CALL NO. 101  
CONTRACT ID NO. 111313  
ADDENDUM # 2

Subject: Jefferson County, HPP 0163 (032)  
Letting April 22, 2011

- (1) Revised - Plan Sheets - C4001, C5001, CS1000, CS1001, & G0002
- (2) Revised - Note - Pages 320-331 of 471
- (3) Added - Addendum No. 2 - Pages 426(g)-426(p) of 471
- (4) Revised - Bid Items - Page 471 of 471

**The Parklands of Floyds Fork - Project 2A**  
 Beckley Creek Park - North  
 Louisville, Kentucky  
 Owner:  
 21st Century Parks, Inc.  
 471 W. Main St., Suite 202  
 Louisville, Kentucky 40202

Drawing No. **G-0002**

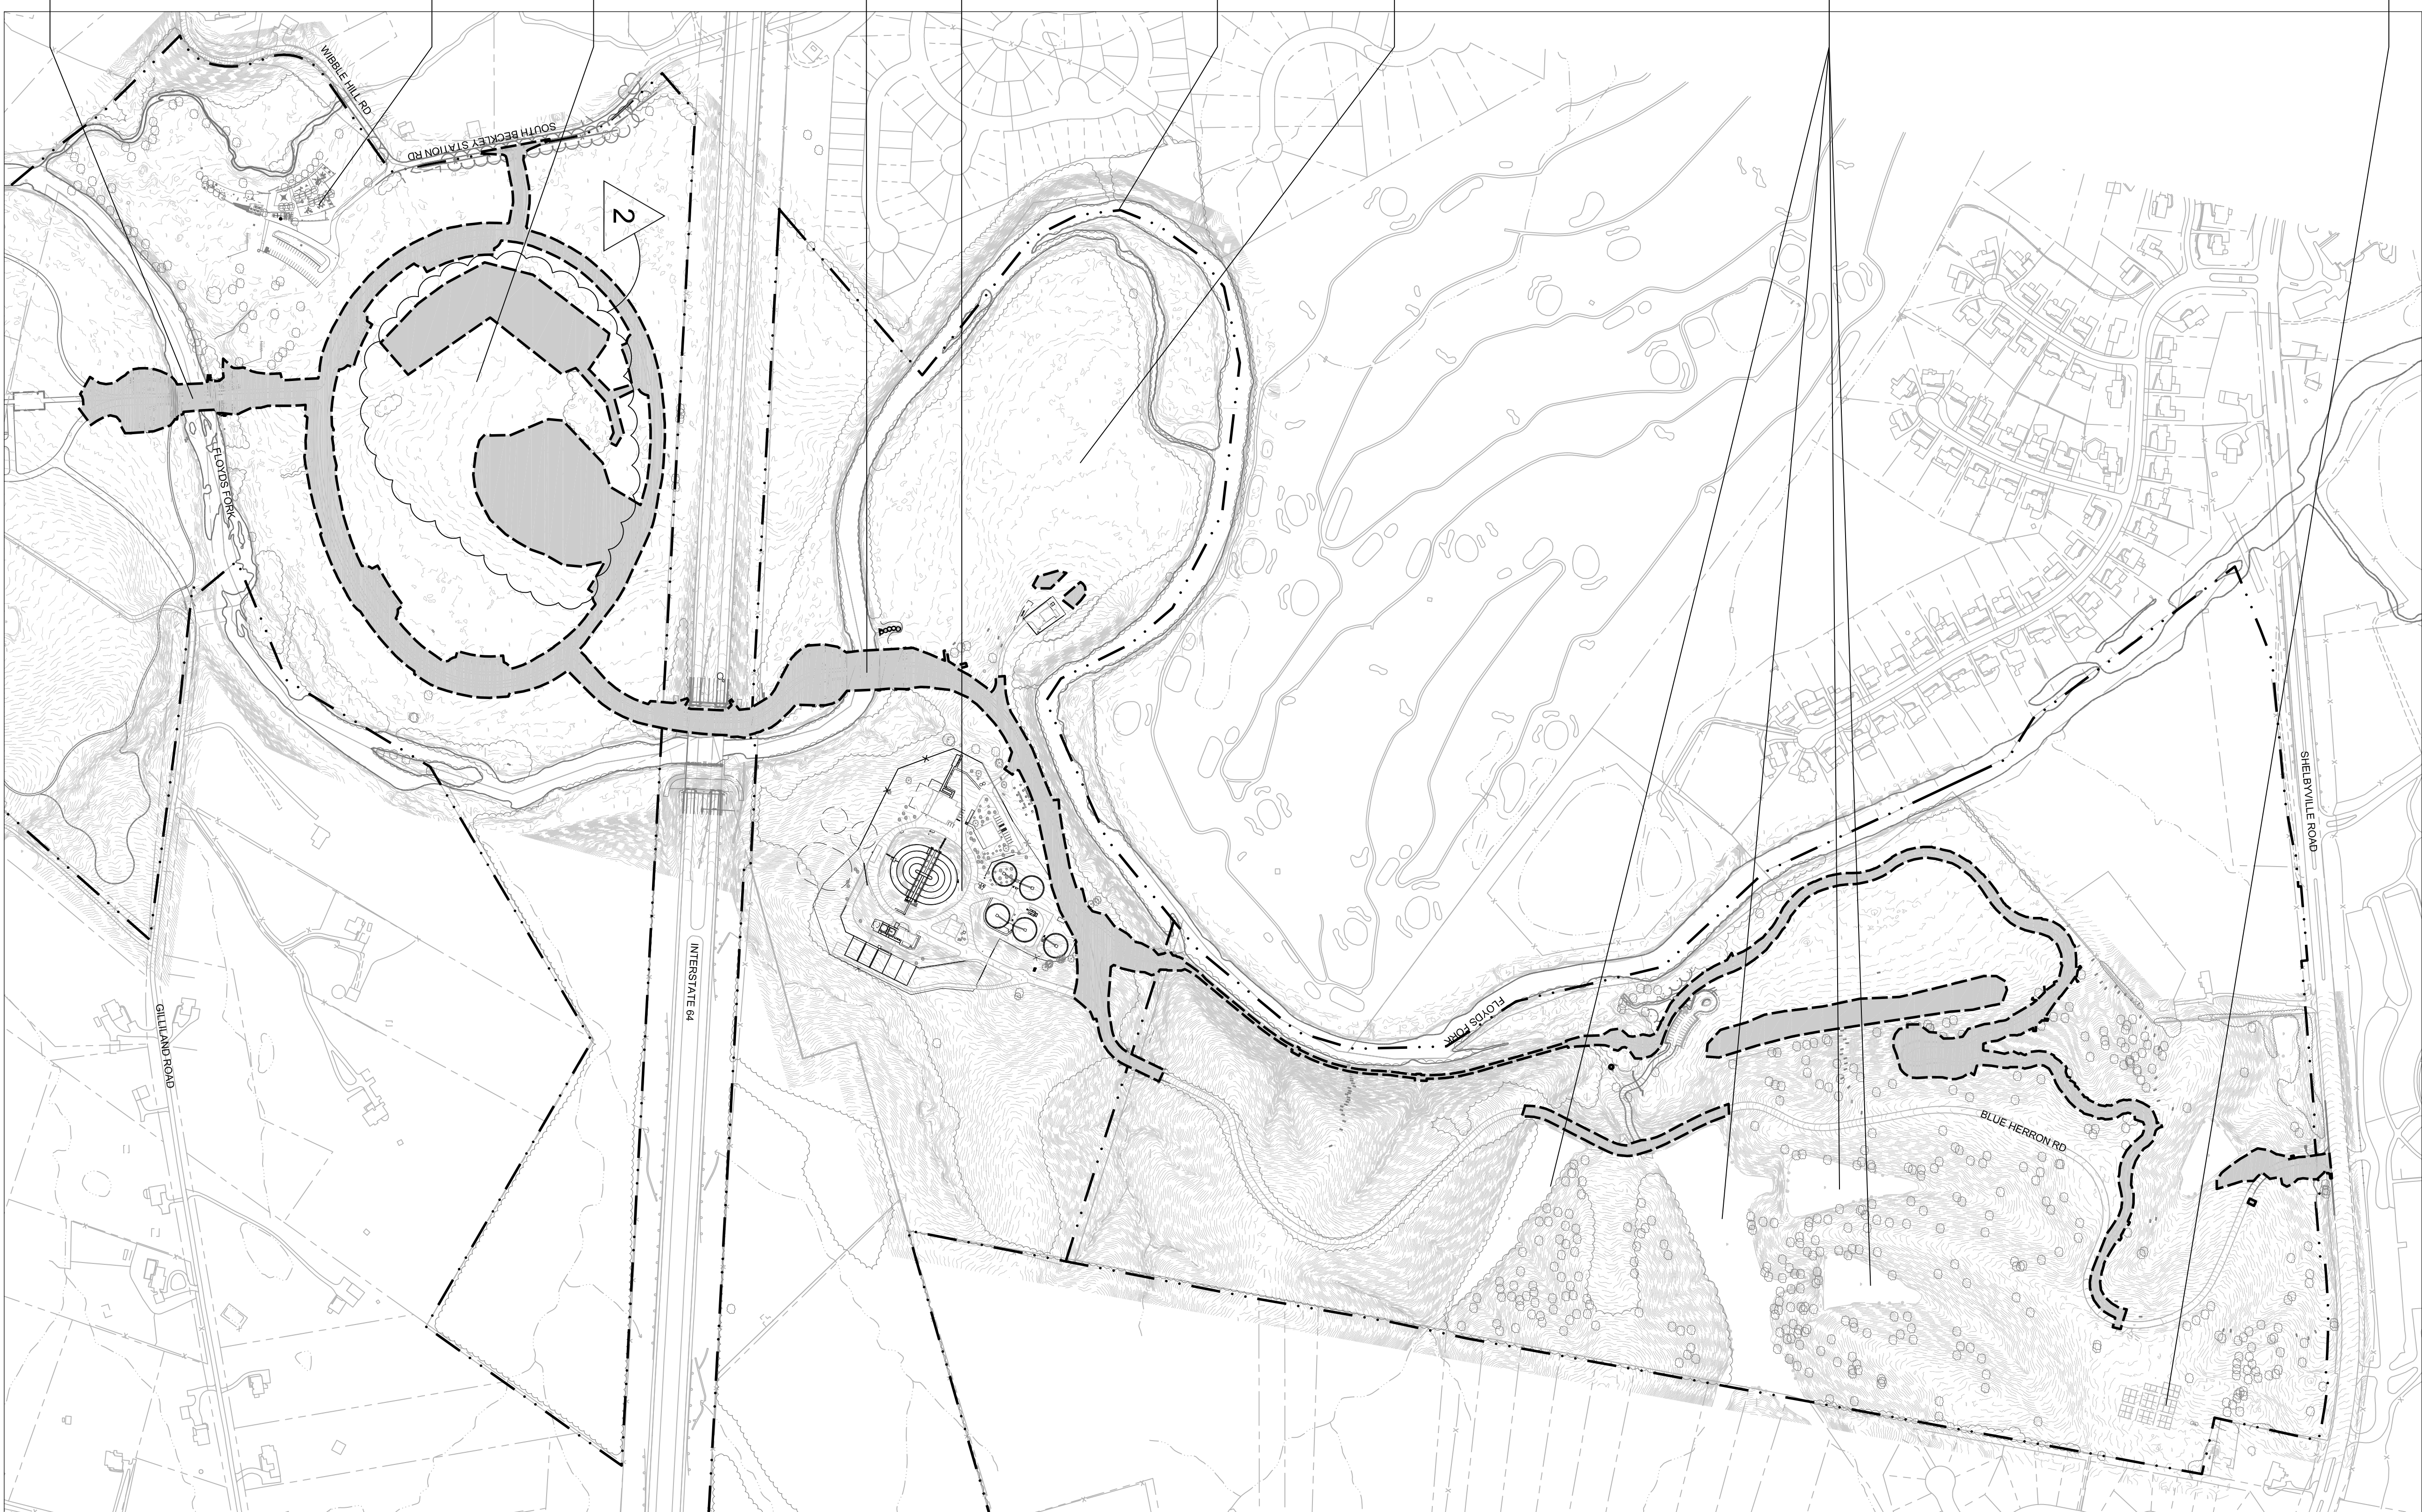
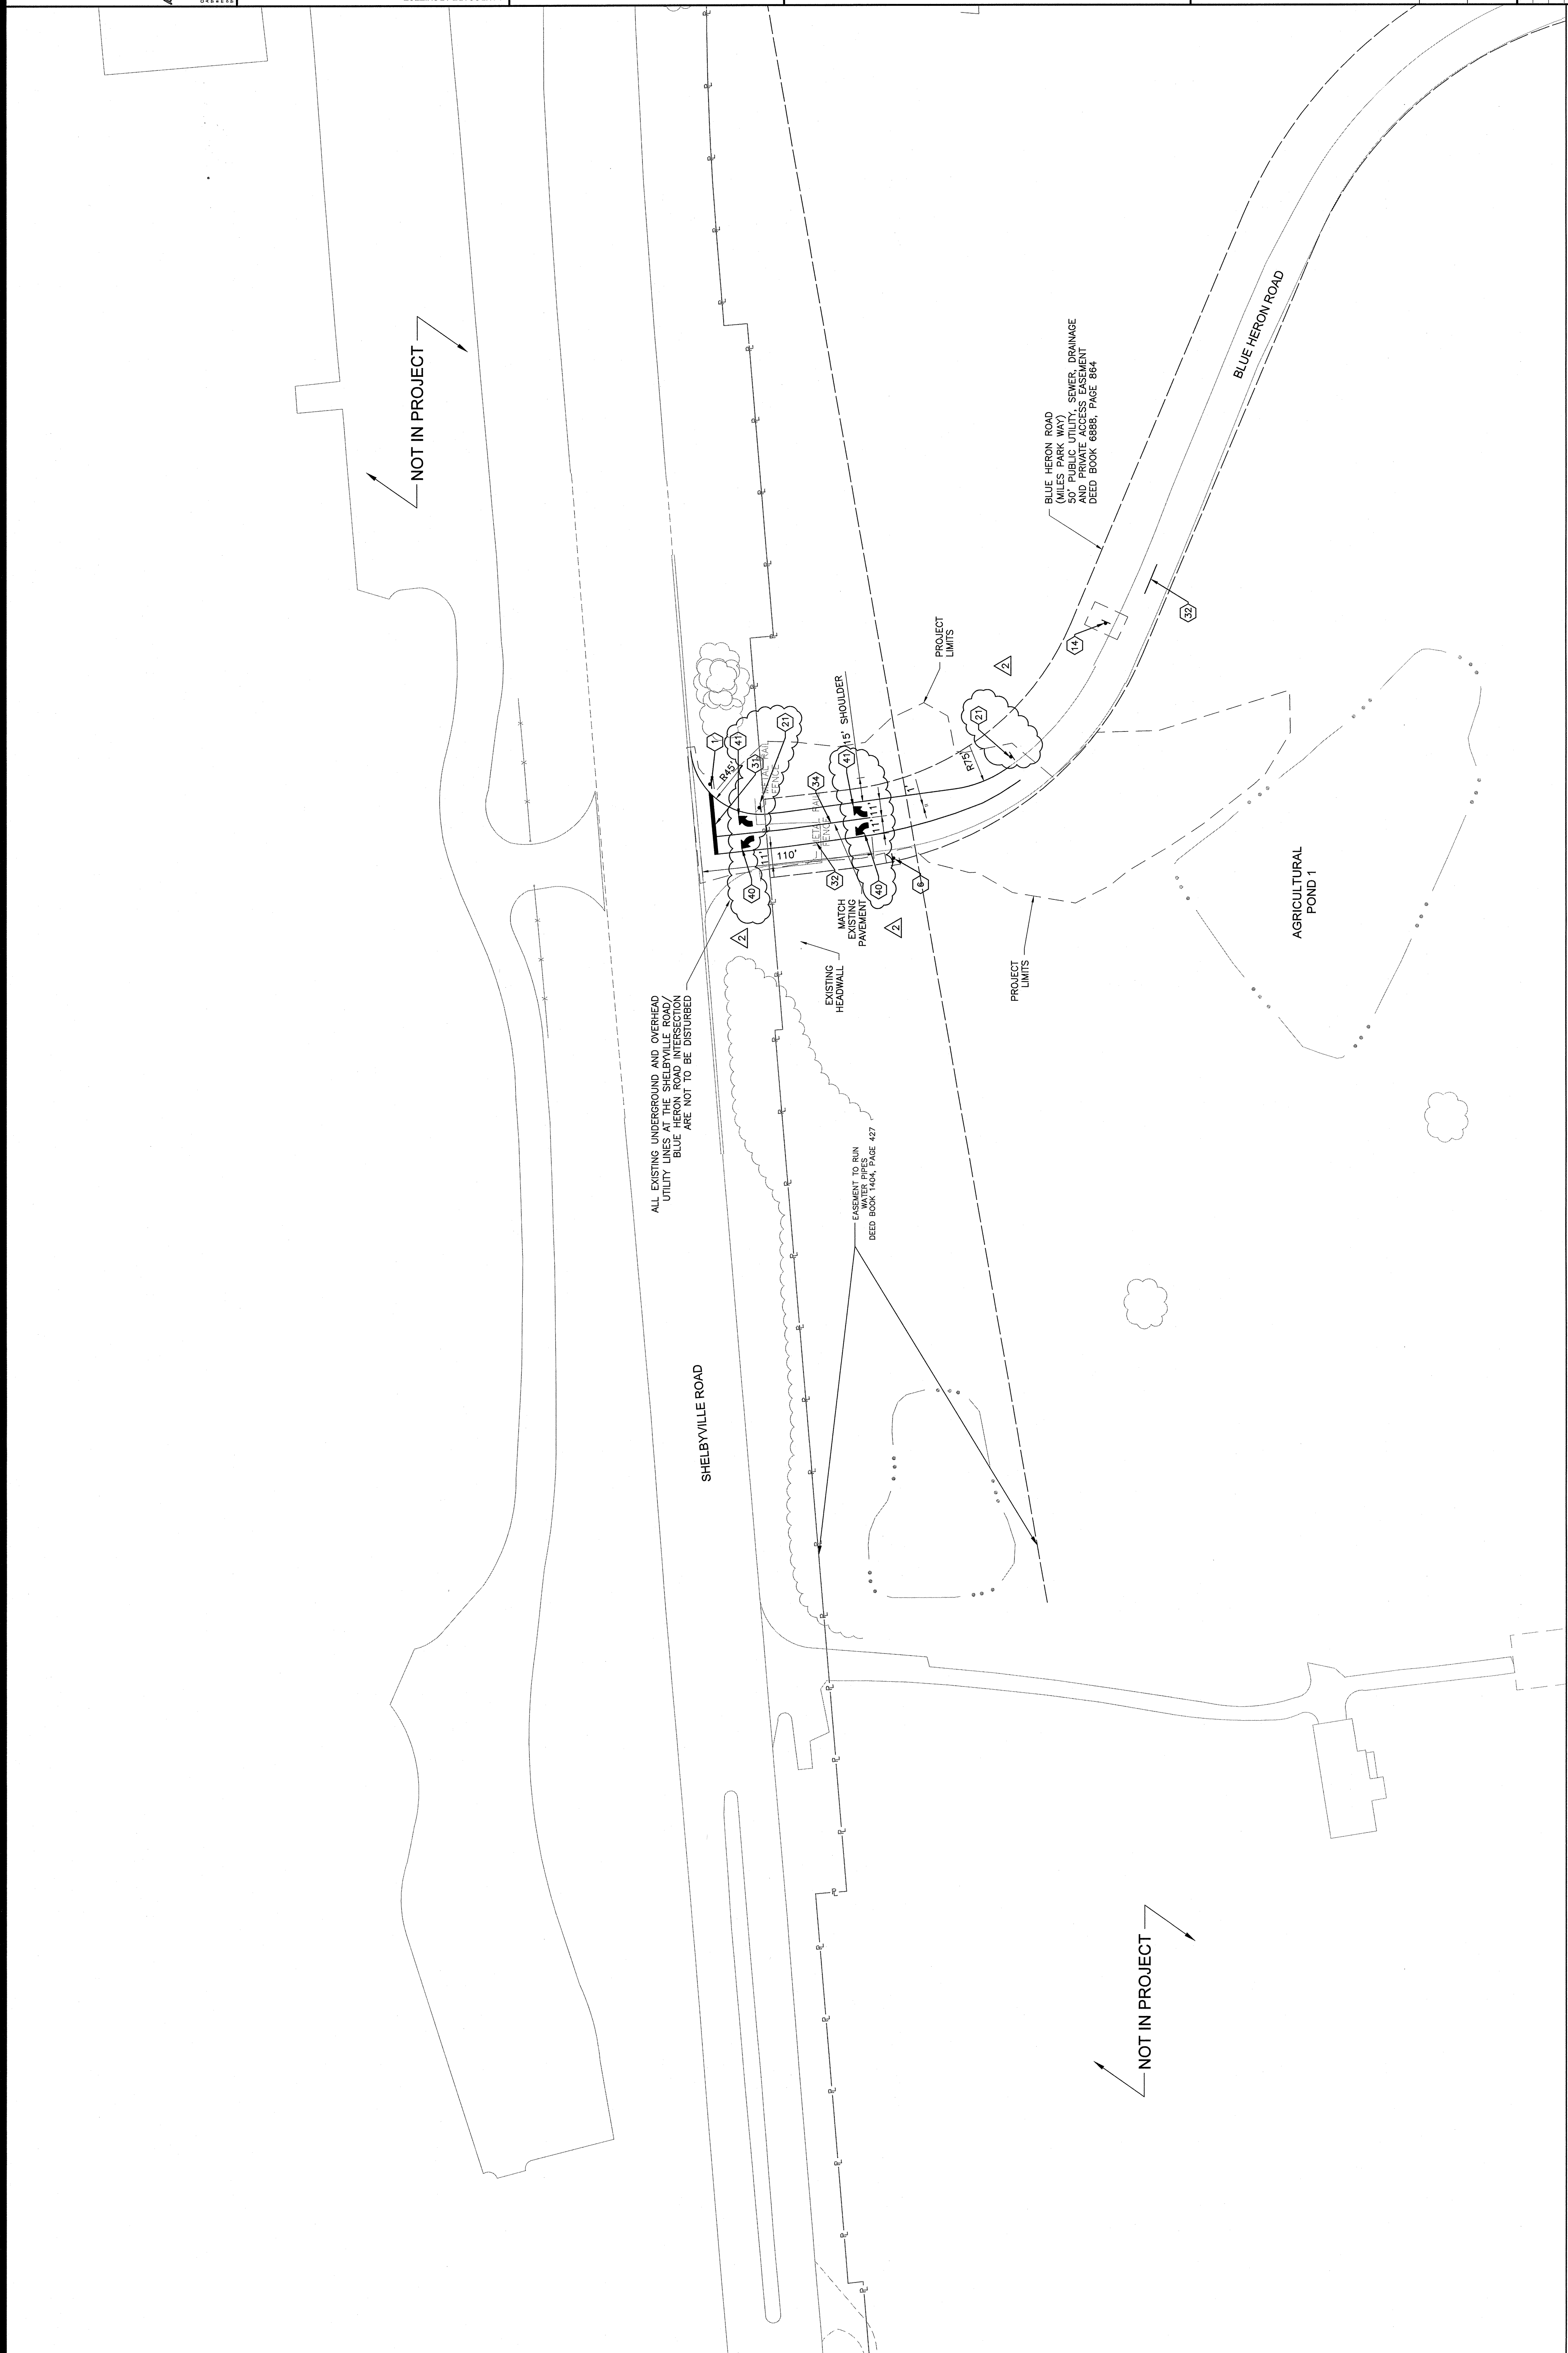
Sheet G-0002 shows a large disturbed area inside of the egg lawn loop. Sheet CD-1017 does not show work in this area. Is there any work required at this location? Would it be possible to borrow material in this location?

The large disturbed area inside the Egg Lawn Loop is for tree protection of existing tree stands and for spoil sites. The extend of this disturbed area on Sheet G-0002 will be expanded to include areas to the west inside of the Egg lawn Loop. This drawing will be included in the next addendum. Since these are spoil sites on an existing grass site, we did not show any demolition for this area on Sheet CD-1017. All borrow material will be available from on-site locations. The exact locations will be determined by 21CP and will be located within the 2A Project boundary.

G-0002	The Project 2A Limits of Primary Disturbance have been revised to include areas to the west inside of the Egg Lawn Loop.
CS-1000	Coded Notes Table revisions:
